Subject: Site Location of Development Law and Natural Resources Protection Act Applications on behalf of Calais LNG Project Company, LLC & Calais LNG Pipeline Company, LLC, Calais Response to MEDEP Comment letter dated March 30, 2010

This letter is to submit additional information and clarification to address the comments provided to you by David Waddell in a Technical Review Memorandum dated March 29, 2010, which specifically reference Sections 12 and 14 of the Site Location of Development (SLOD) Permit application submitted to you in January, 2010. The numbered responses correspond to the numbered comments in David's letter.

**SLDOD FIGURE  
12-5B REV**

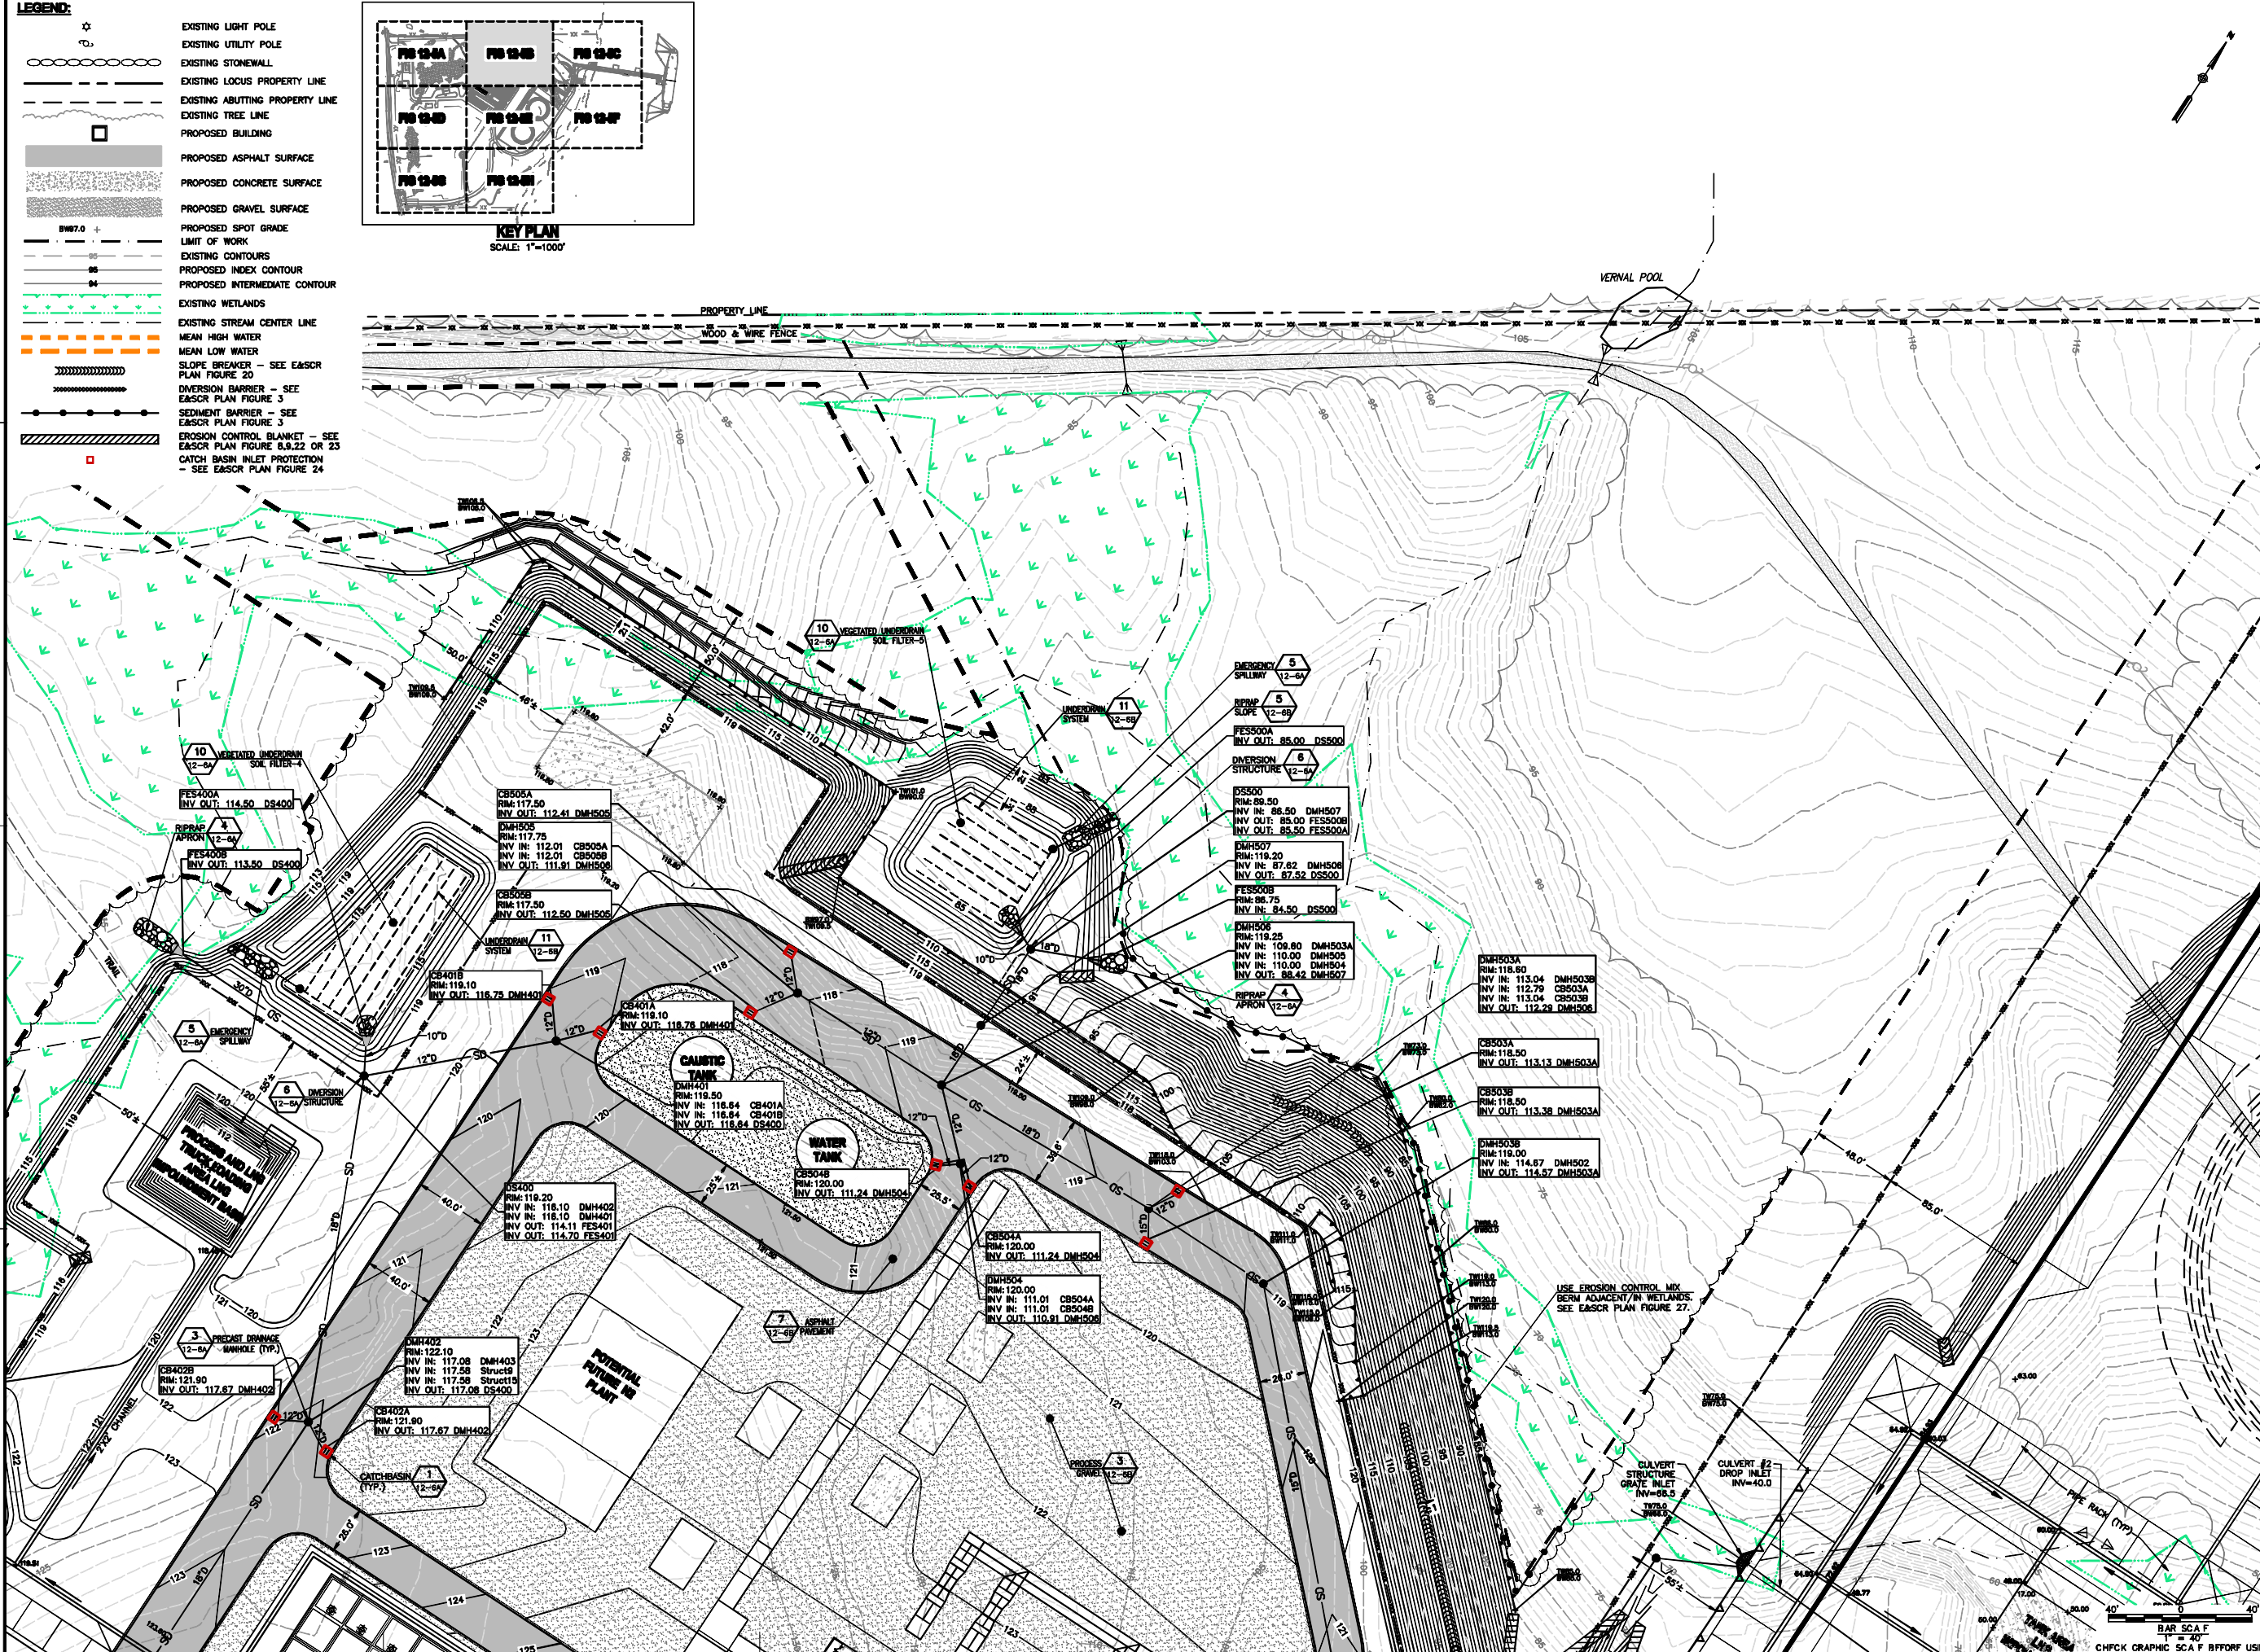
please find detailed Grading Plans of the Terminal Site (SLOD Figures 12-5A REV through 12-5H REV), which have been revised to show critical locations for installation of temporary erosion and sediment control measures.

**SLOD FIGURE 12-5D REV**

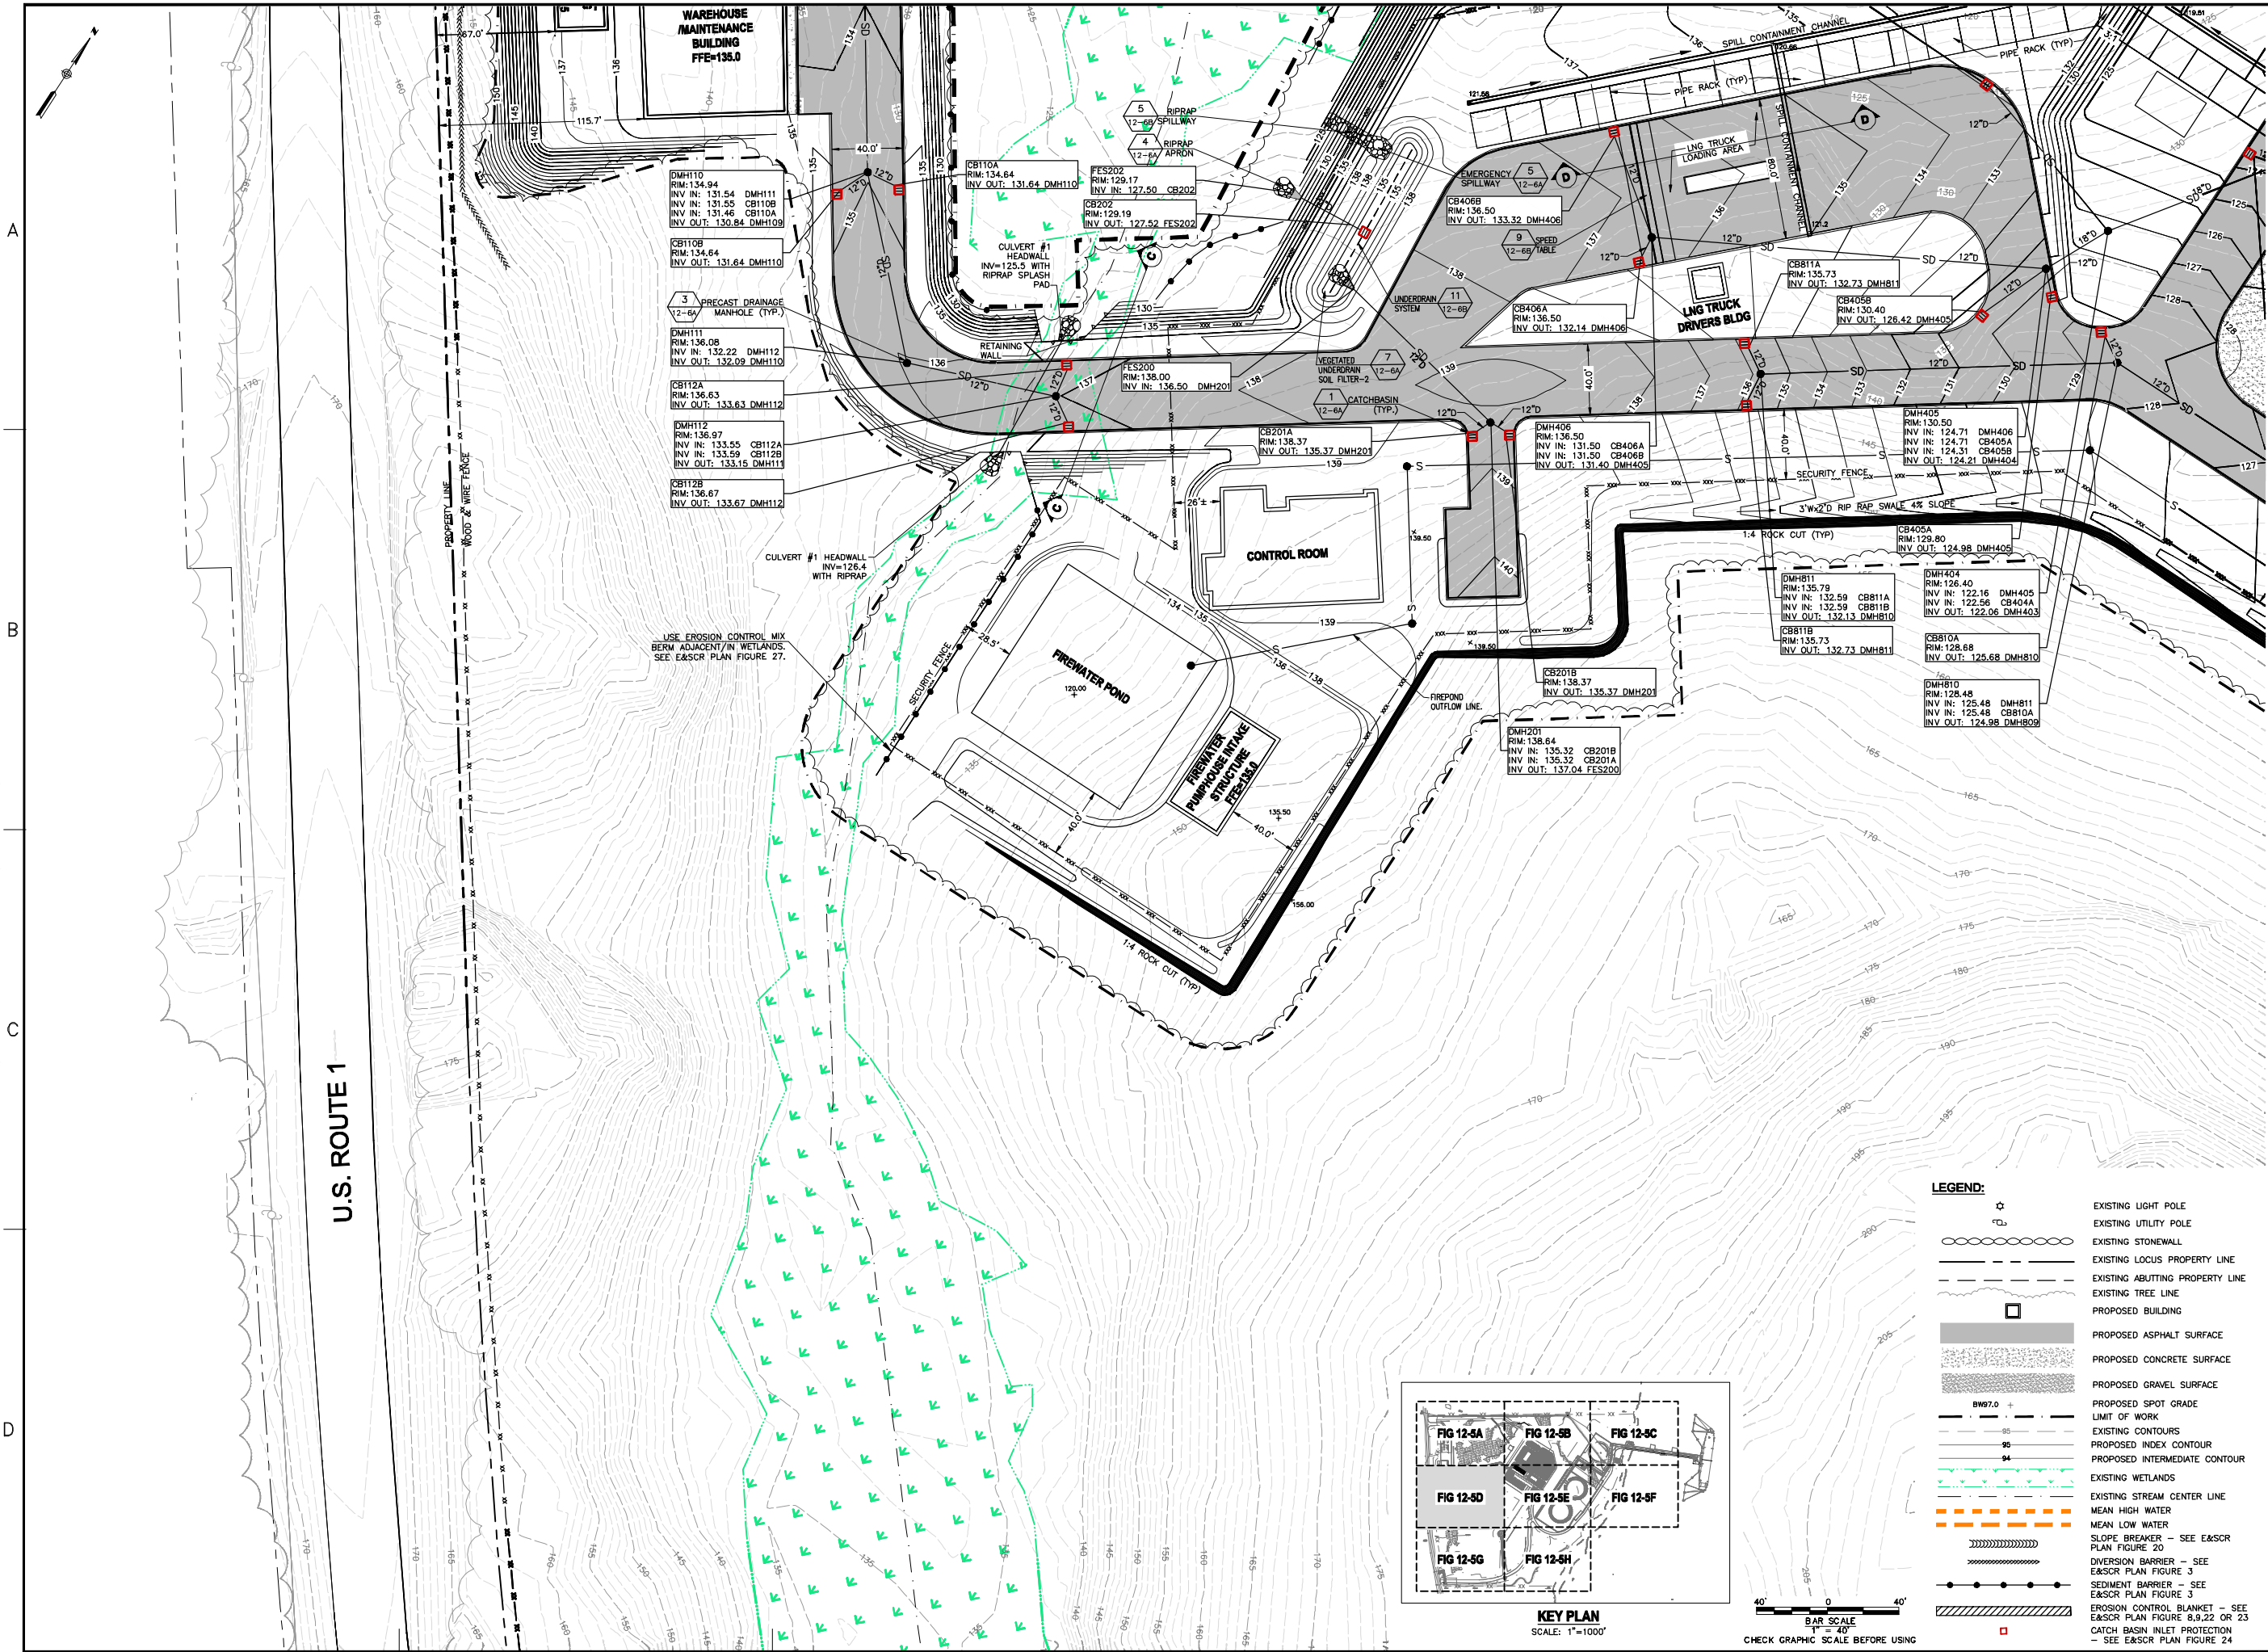
14. Cross-section A on SLOD Figure 12-6C is through the entrance road and buffer shown in plan view on Figure 12-5G. The cross-section is correct. The table below matches cross-sections to their plan view locations for ease of reference.
